**Re: Condition A9 and requirements in Schedule C of your REA  
Renewable Energy Approval # 0871-AV3TFM (Approval)  
Nation Rise Wind Farm  
Cornwall City, United Counties of Stormont, Dundas and Glengarry  
Reference Number 6695-APKGUB**

The ministry has reviewed the documents submitted to fulfill Condition A9 and requirements in Schedule C of your Approval, (*refer to Annexes 1, 2 & 3 of this letter for details*).

## Annex - 5 : Updated Transformer Details

**Table 1: 2019 Project substation barrier coordinates vs Approval barrier Coordinates**

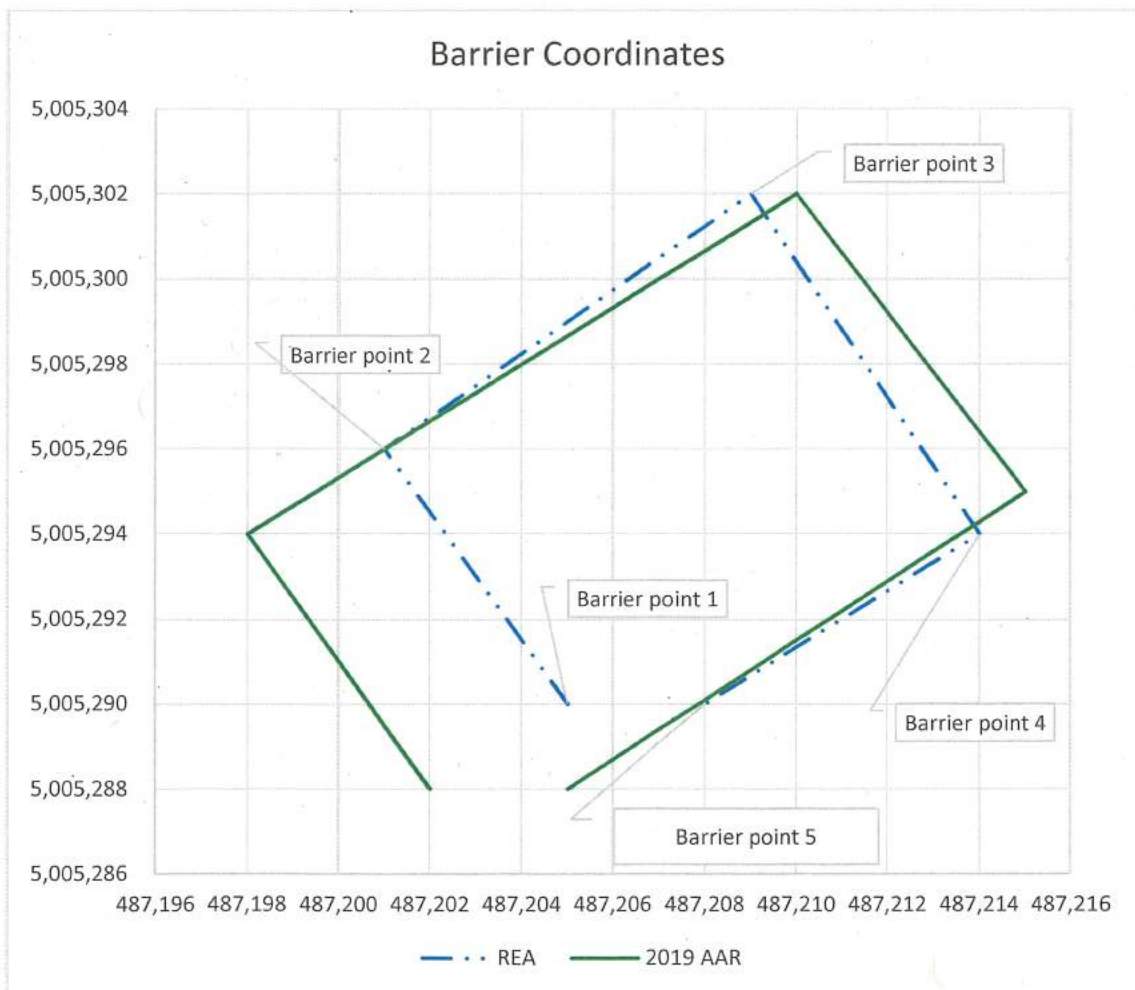
- a. the equivalent turbine is an Enercon E-138 EP3, 3.44 MW (Mode NR2) turbine (*refer to Annex*), and
- b. the selected transformer substation has a sound power level of 101.7 dBA as opposed to 109.9 dBA noted in the Approval. Furthermore, in accordance with provisions in Schedule C of the Approval minor adjustments to the barriers positioning were noted and accounted for to the satisfaction of the ministry. (*Refer to Annex 5*).

Minor adjustments to the barrier's positioning are acceptable, in order to accommodate the final transformer geometric size, as long as the modelled sound levels are equal or below sound levels in the Acoustic Assessment Report. If there are minor adjustments to the barrier alignment an updated Acoustic Assessment Report based on the actual barrier configuration shall be submitted to the Director and the District Manager three (3) months (or a date agreed to in writing by the Director) prior to construction of the acoustic barrier.

A sound barrier is planned for the Project substation transformer. The type of barrier used in the (2019) noise study is one that can be described as of absorptive type with an Absorptive Coefficient of at least 0.8.

The acoustic barriers will have a surface density of at least  $20 \text{ kg/m}^2$  and have a closed surface free of gaps and cracks. A four-sided barrier was modeled with heights ranging from 5 m to 6.05 m. The total barrier linear length is approximately 42 m. The following tables provide details of the substation and acoustic barrier.
